**Amendment 14: Stream Reservation
Protocol (SRP)**

IEEE Std 802.1Qat™-2010
(Amendment to
IEEE Std 802.1Q™-2005)

Abstract: This amendment specifies protocols, procedures, and managed objects, usable by existing higher layer mechanisms, that allow network resources to be reserved for specific traffic streams traversing a bridged local area network.

Figure 10-5—Format of the major components of an MRPDU

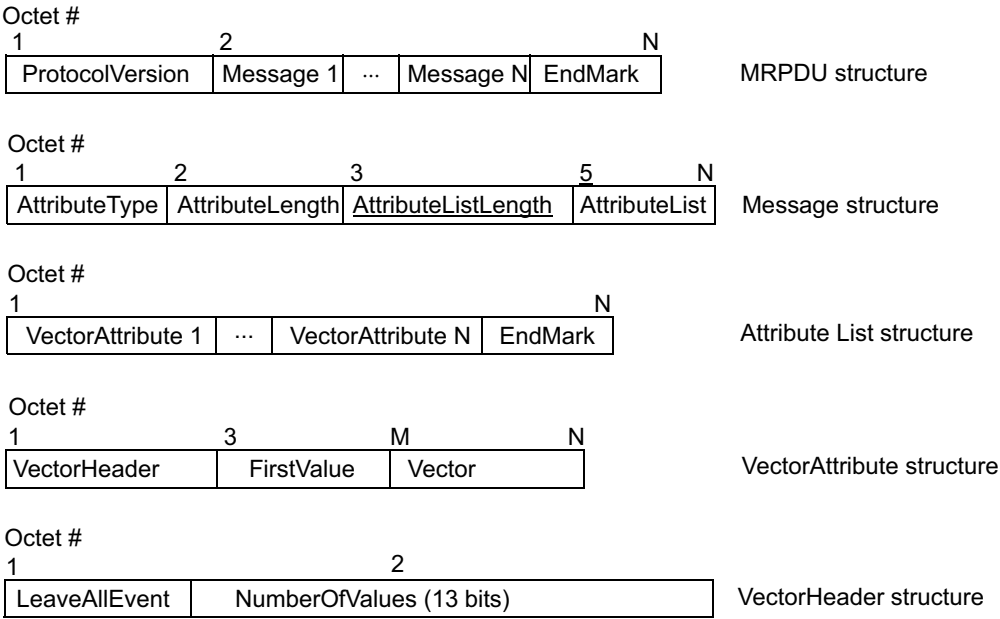
Change Figure 10-5 as follows:
